DARLINGTON PUBLIC SCHOOL
 SSD - 9914 ARCHITECTURAL DESIGN UPDATE

FOLLOWING RESPONSE TO SUBMISSIONS

GOLDEN GROVE STREET, DARLINGTON, SYDNEY
 Department of Education

Project Name		Darlington Public School	
Project Code		DTPS	
Document Name		SSD-9914 Architectural Design Update	
Revision	Date	Comment	Approved
REV 00	20.08.20	Design Change Report	EC

1.0 HALL VOLUME

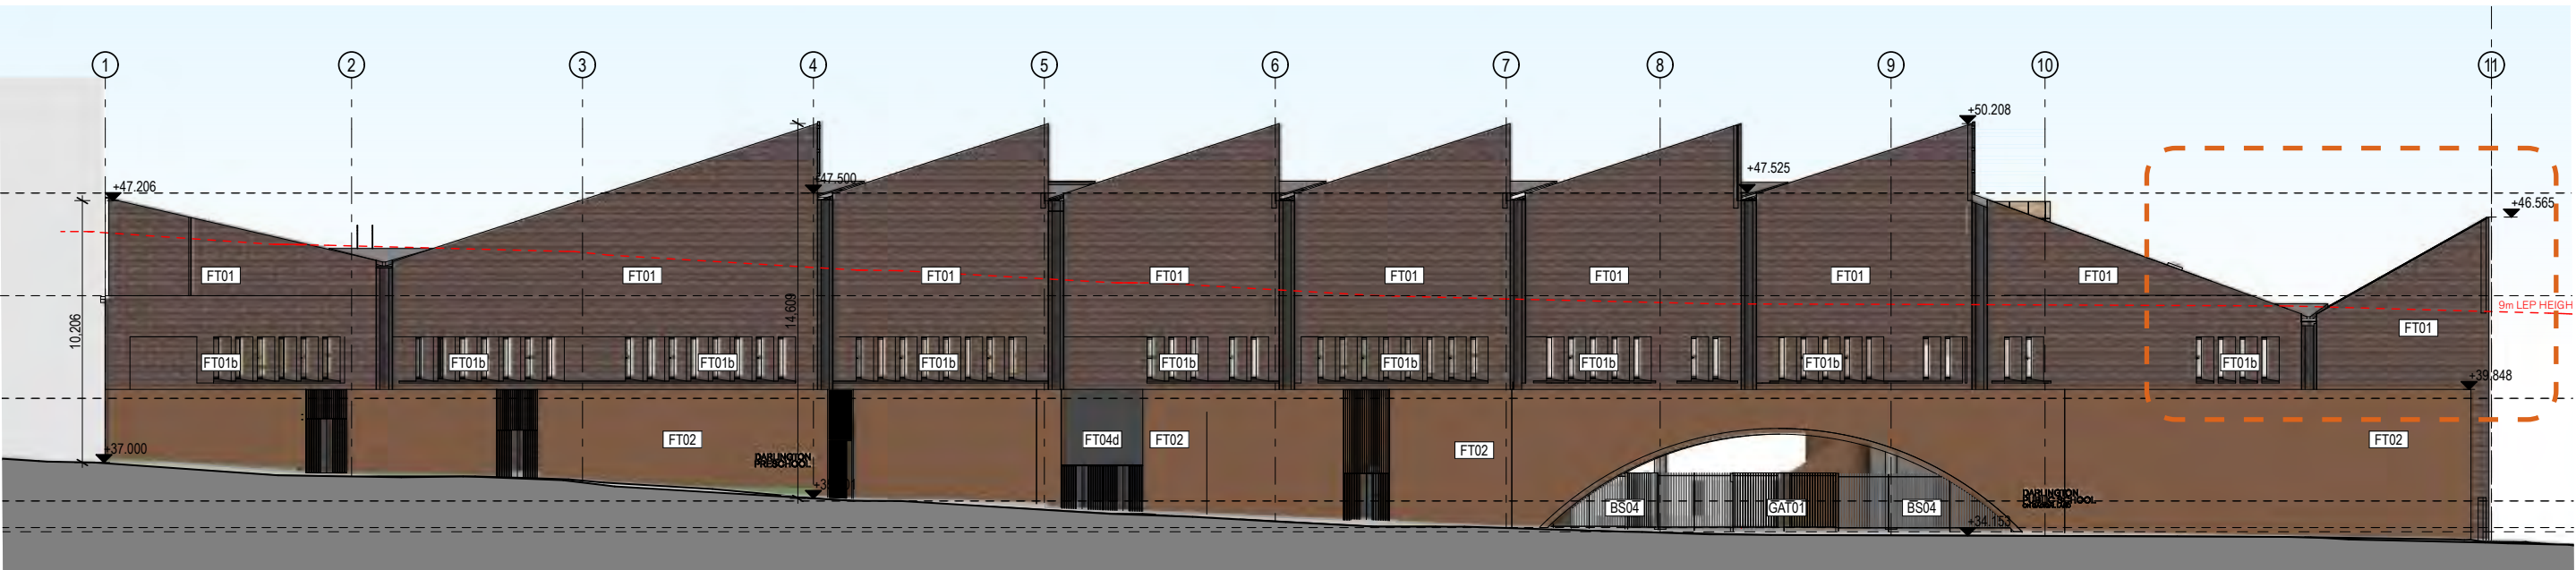
1.0 Reduction in height of the southern-most sawtooth roof

- During design development it was revealed that the ceiling height of the hall was too high and needed to be reduced to provide a more efficient and proportionate response.
- This has been done by still maintaining the sawtooth form and recognising the importance of the civic scale at the corner of Golden Grove and Abercrombie Streets.

Updated Facade Sections

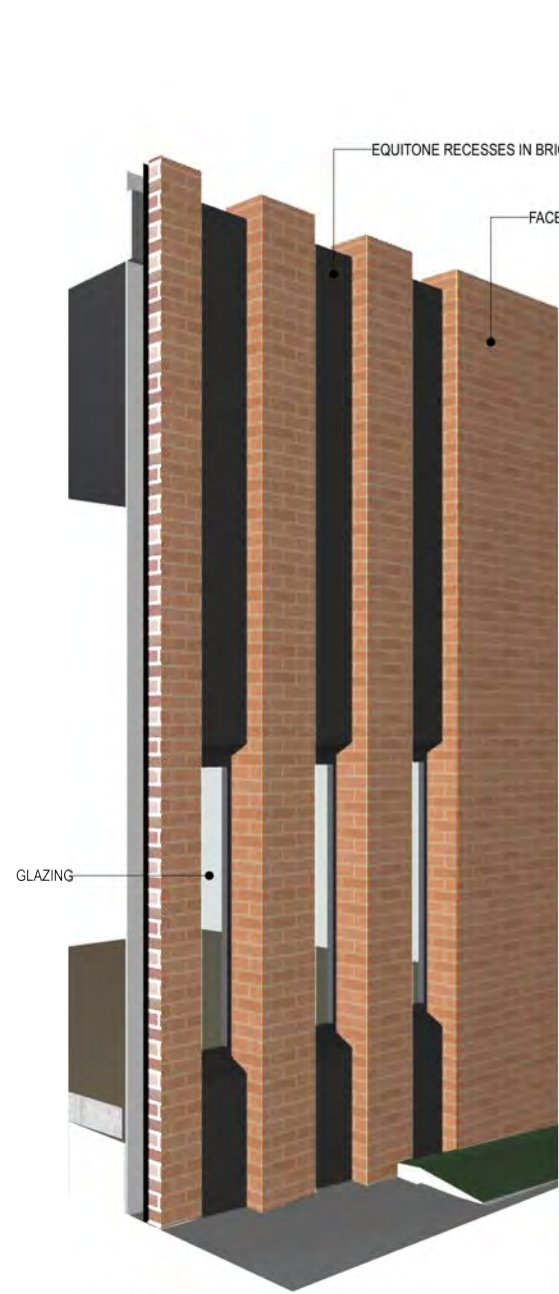
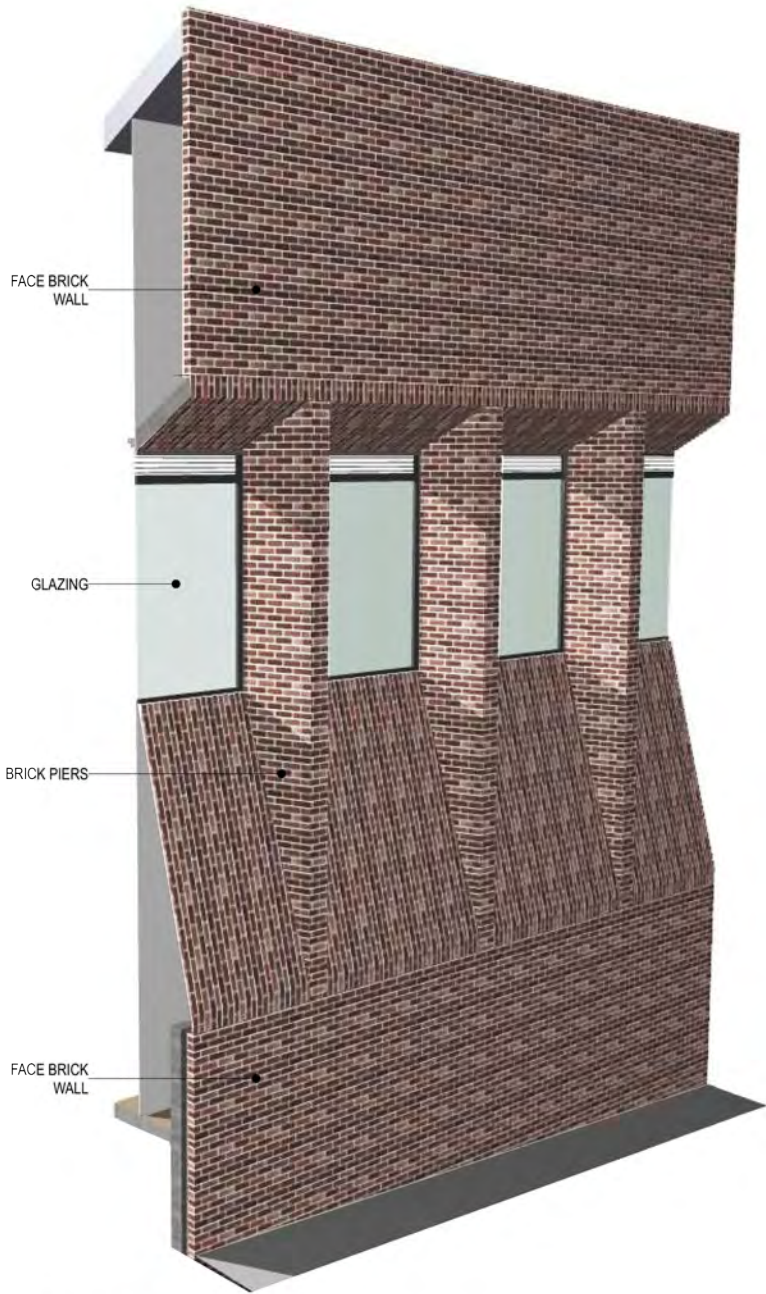
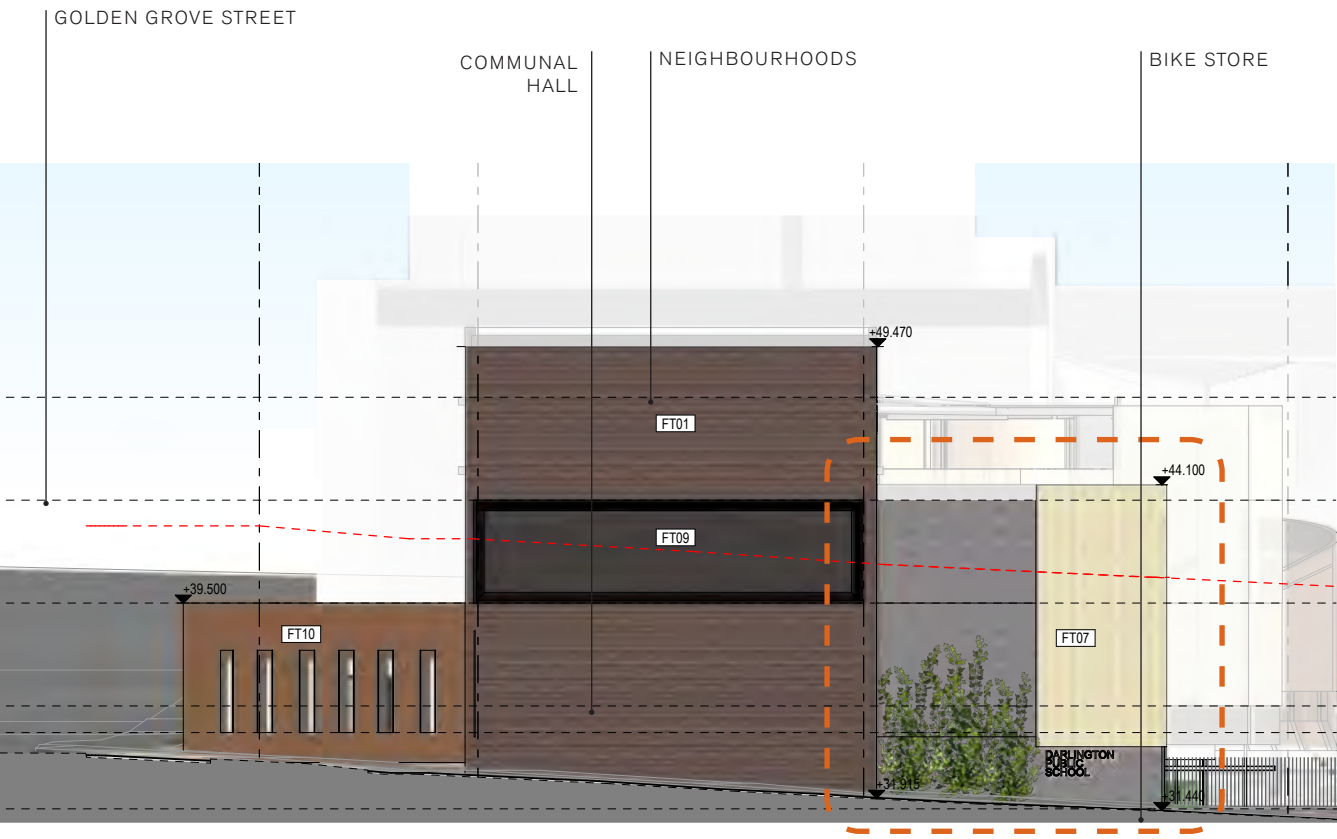
2.0 Articulation of the Southern Facade

- The glazing and brickwork to the southern facade of the hall building has been articulated to provide a finer grain response to the streetscape.
- The previous single large window into the south facade of the communal hall has been divided into 5 smaller windows. These are set into a recessed brick facade with large splayed sills and clearly defined brick blades between the glazing elements.
- This creates a more interesting street frontage, responding to the local context and a more structurally efficient result.

Elevation Comparison

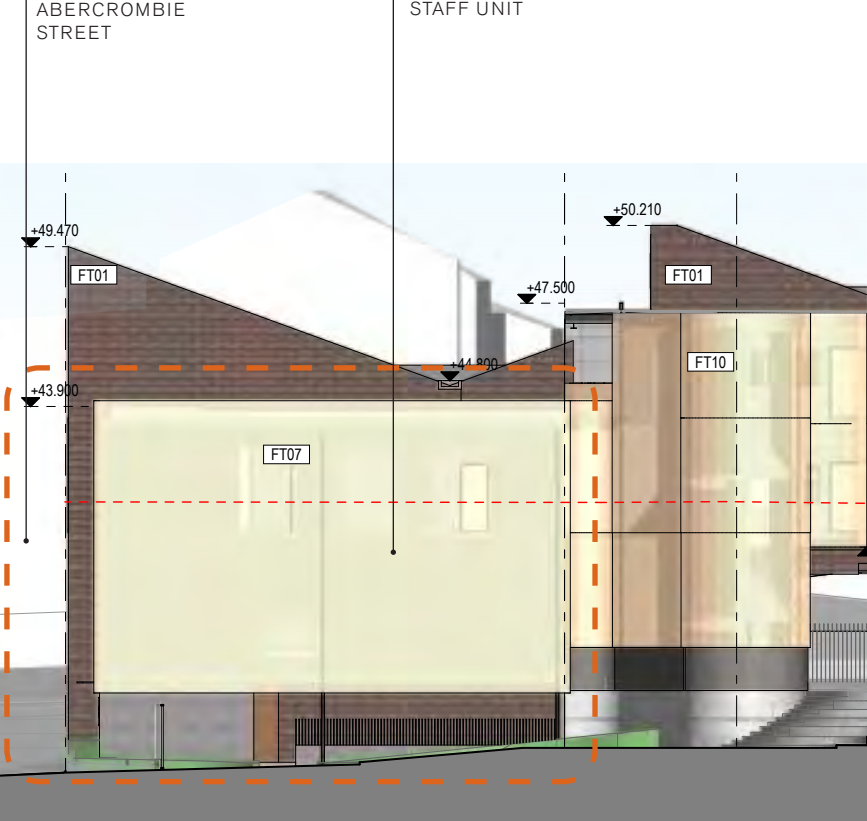
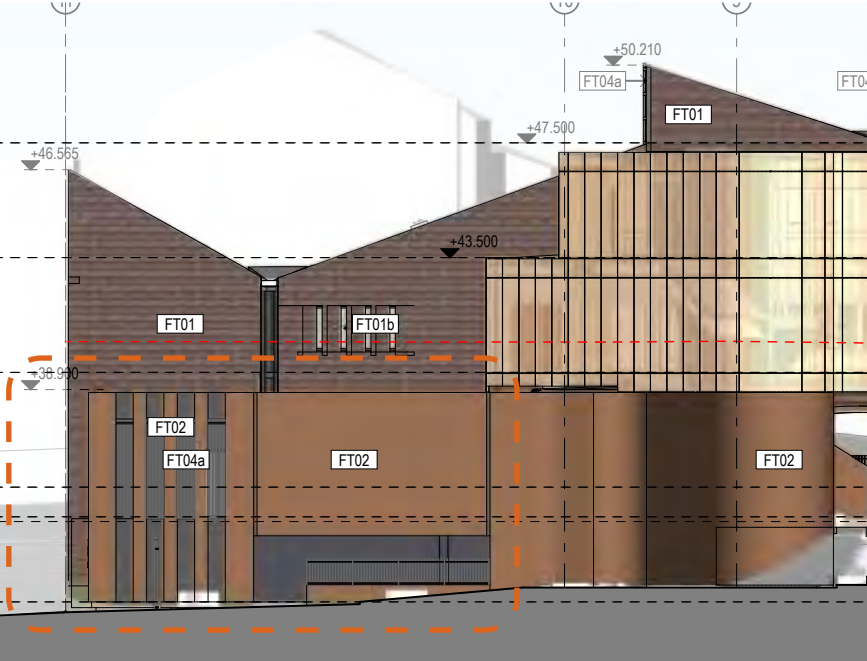
3.0 Reduction in bulk of the south-eastern wing

- Due to the large volume above the hall, it was decided that the staff area could be moved from the east wing, to above the hall. This has resulted in a reduction in height and bulk on the eastern side of the hall whilst still holding a strong alignment to the street through both the lower form and landscaping.

Facade Sections

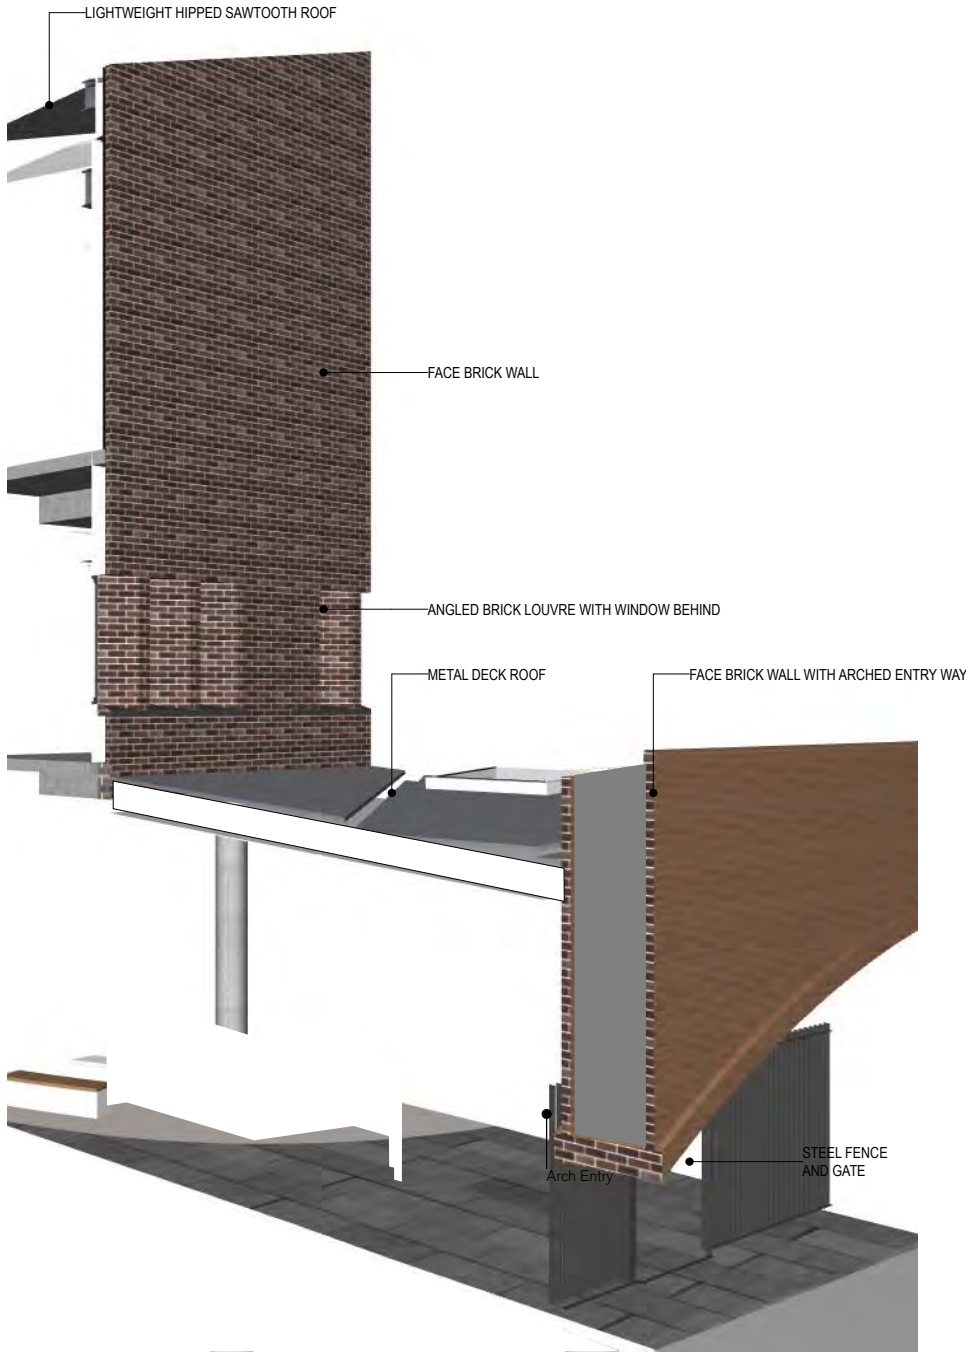
4.0 Change to Level 1 western facade

- The windows to the level 1 classrooms on the western facade (Golden Grove Street) have been changed from vertical slot windows to horizontal strip windows with vertical brick external blades, which provide solar shading from the western sun.
- This provides a larger expanse of light and views out from the classrooms, and a more integrated approach to the fenestration in this facade.
- In addition to this, a window has been added on the southern end of the western facade, due to the new staff room location above the hall.

Lower Ground Floor Plan Comparisons

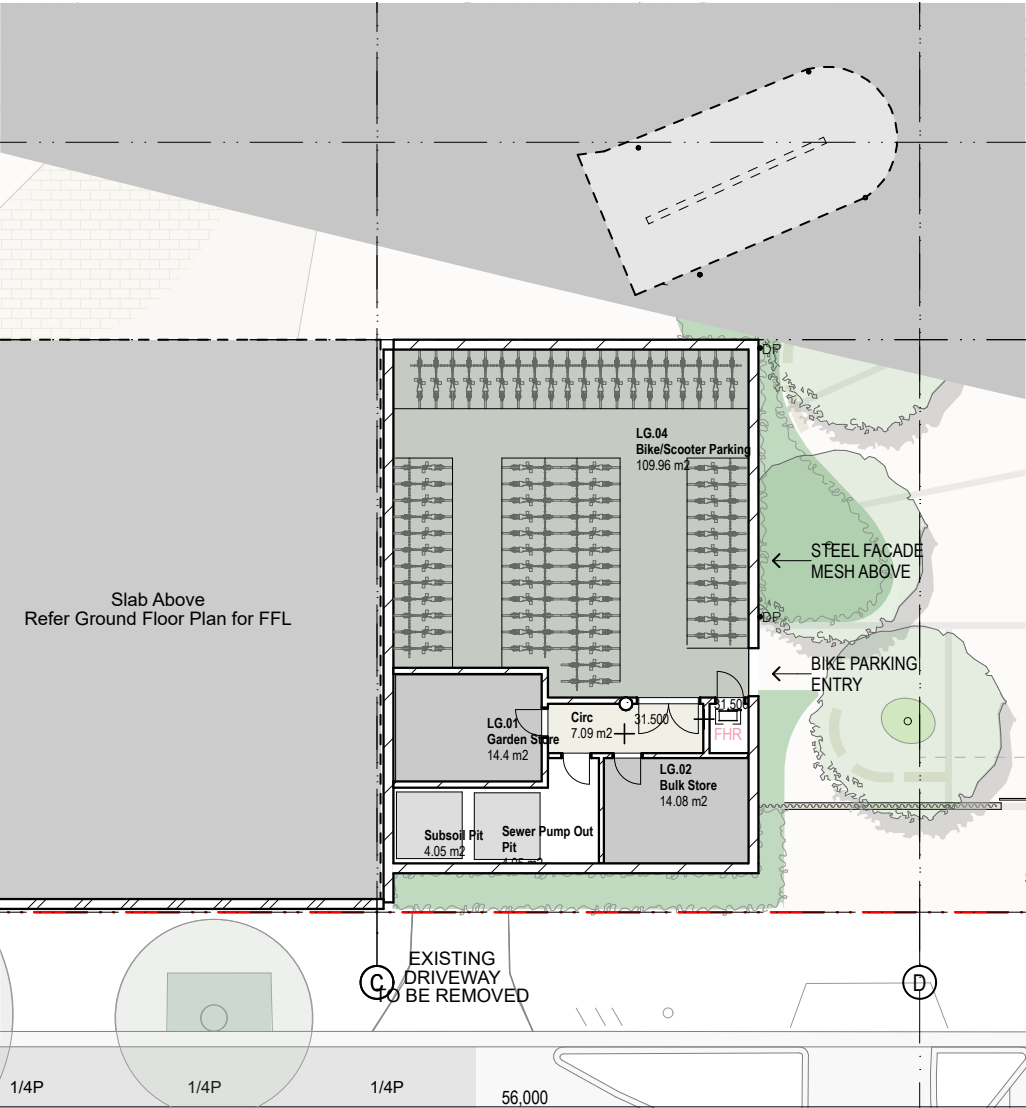
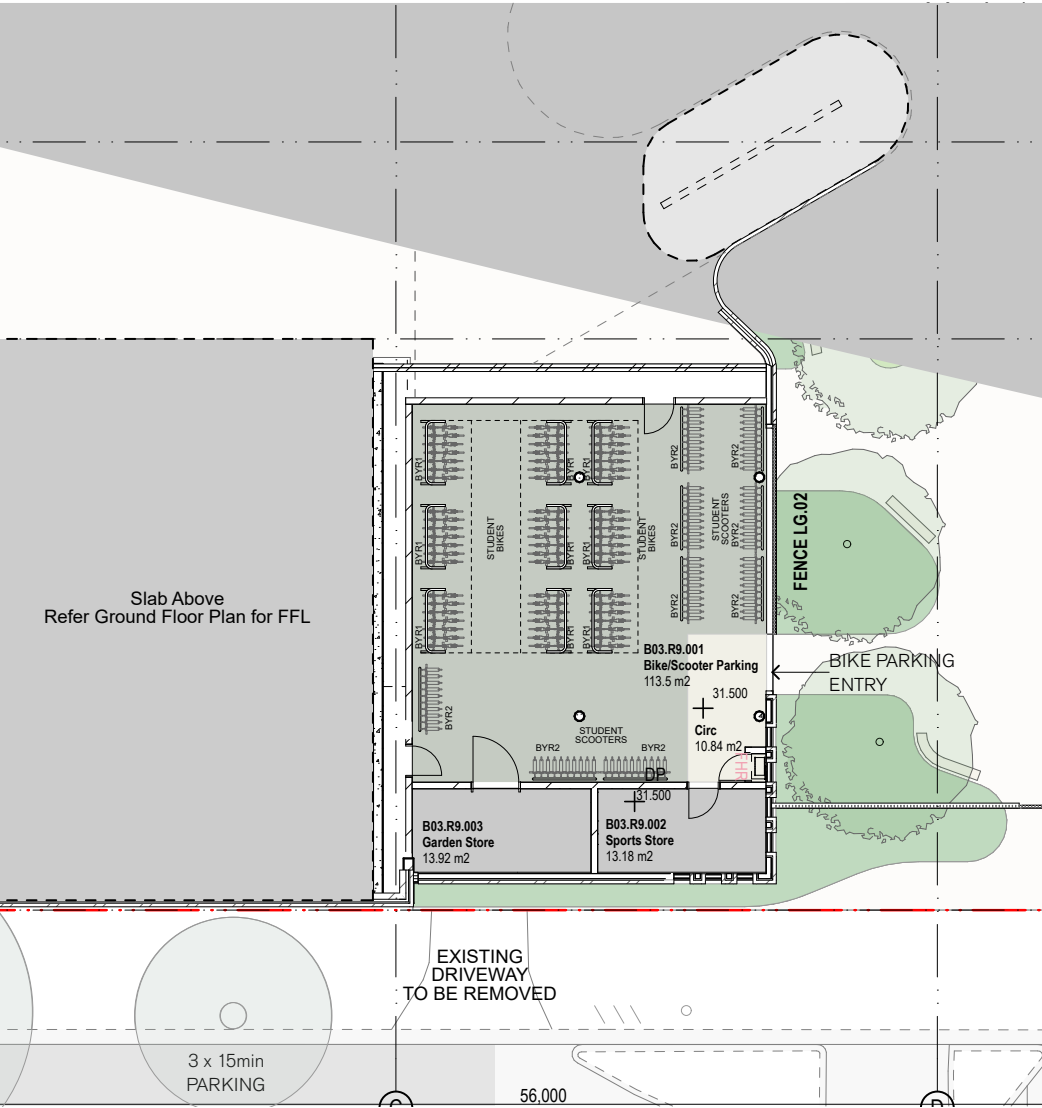
One of the Response to Submissions raised a query regarding the number of bicycle spaces for students.

The bicycle storage area has been re-planned and we have been able to accomodate an increase in bicycle and scooter parking.

As a result, we now have 63 student bikes (9 junior bike racks that can hold 7 bikes each) and 110 scooters (10 scooters per rack), totaling 173 spaces for student bikes and scooters.

In addition, we have storage for 8 staff bicycles in the secure courtyard adjacent to Golden Grove Street.
